## Alcatel 525 cable problem for UB v2.0, v3.0 or UltraLOGIC

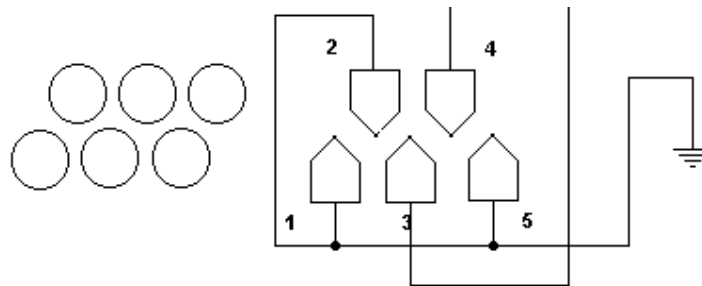
- 1) Open cable connector 525
- 2) You will found 3 wires connected – GND (connected with 3 pins), TX and RX as photo shown below:

**1,2,5 pin - GND**

**4 pin - TX**

**3 pin – RX**

All you must to do is connect 10K resistor before RX (pin 3) so cable after change will looks like below:
